## SUMMARY OF CONCERNS IN RELATION TO THE PROPOSED NORTHCONNEX TUNNEL

**This is an objection to many aspects of the proposed NorthConnex tunnel.**

## SECTION A: THE CONNECTIVITY OF NORTHCONNEX SOUTHERN VENTILATION FACILITY AT THE SOUTHERN INTERCHANGE, THE SOUTHBOUND TUNNEL IN PARTICULAR

MOTORWAY OPERATIONS COMPLEX - SOUTHERN VENTILATION FACILITY - SECTIONS  
M1-M2-5000-DR-JD-0525

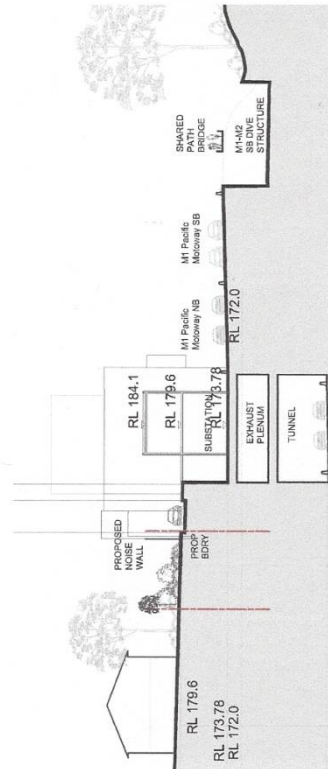
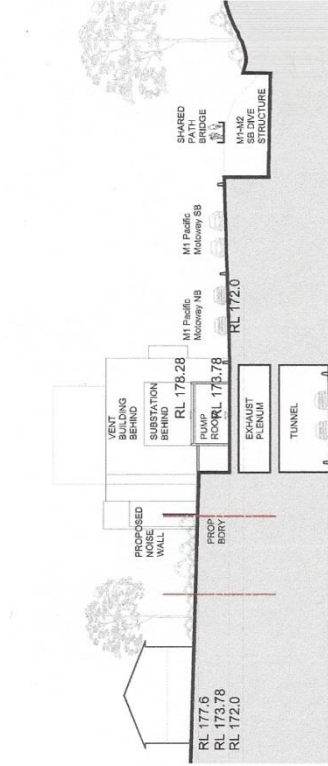
5. *EIS Volume 4, Technical working papers - Urban Design, 6.0 Operational Ancillary Facilities*  
EIS Page 99 there is the diagram "Motorway Operations Complex – Southern Ventilation Facility – sections. *Page 10 below* The diagram has the cryptic label "Connection to tunnel TBC". What does TBC stand for? To be considered? Why is tunnel singular? Which tunnel is the diagram referring to northbound or southbound? There is no diagram showing any connection from the Southern Interchange ventilation facility to either the northbound or the southbound tunnel in any way  
AND YET ....

- Diagrams need to be provided showing the inter-relation between the shaft, the ventilation outlet and the motorway operations centre with a clear description of what is to be constructed and how it will operate.
- The community needs irrefutable evidence that the polluted air from the southbound tunnel exit portals will not be allowed to flow like an invisible sewer through West Pennant Hills, North Rocks, Carlingford and Beecroft.

M1-M2-5000-DR-UD-0556  
NORTHERN VENTILATION FACILITY - LONG SECTION

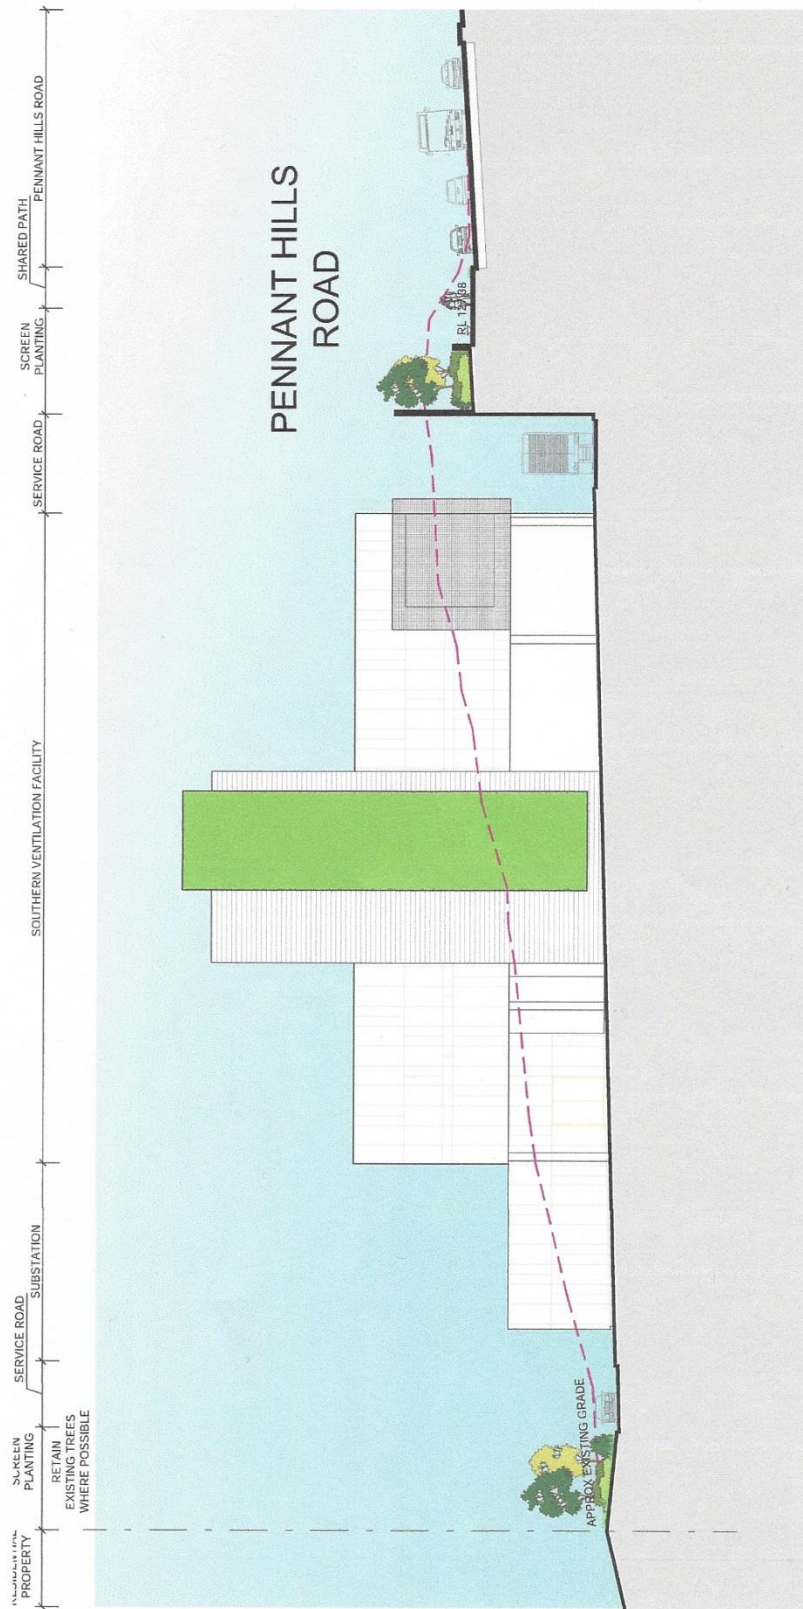
EIS page 135 *Page 11 below* there is a very explicit diagram showing the *Northern Ventilation Facility – cross section*.

EIS page 134 *Page 12 below* there is a very explicit diagram showing the *Northern Ventilation Facility – long section*.

Why are there no comparable diagrams for the Southern Interchange and the Southern Ventilation facility?

MOTORWAY OPERATIONS COMPLEX - SOUTHERN VENTILATION FACILITY - SITE SECTION 1-1  
M1-M2-5000-DR-UD-0713

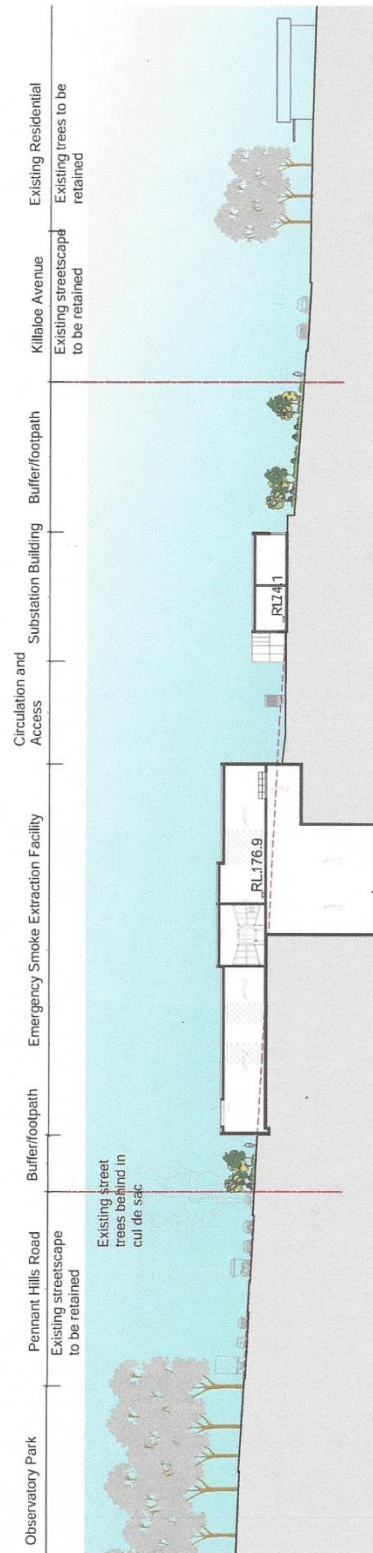
6. *EIS Volume 4, Technical working papers Urban Design, 8.0 Landscape Design*  
EIS Page 176 is the diagram "Motorway Operations Complex – Southern Ventilation Facility – Site 1-1". *Page 13 below* The diagram does not show any connection to either the northbound or southbound tunnel. In the same Landscape Design section, EIS Page 182 is the diagram "Wilson Road Tunnel Support Facility –Section" *Page 14 below* which clearly shows the connection to the tunnels. In the same Landscape Design section, EIS Page 189 is the diagram "Northern Ventilation Facility – Landscape Concept Section". *Page 15 below* This also clearly shows the connection to the tunnels.
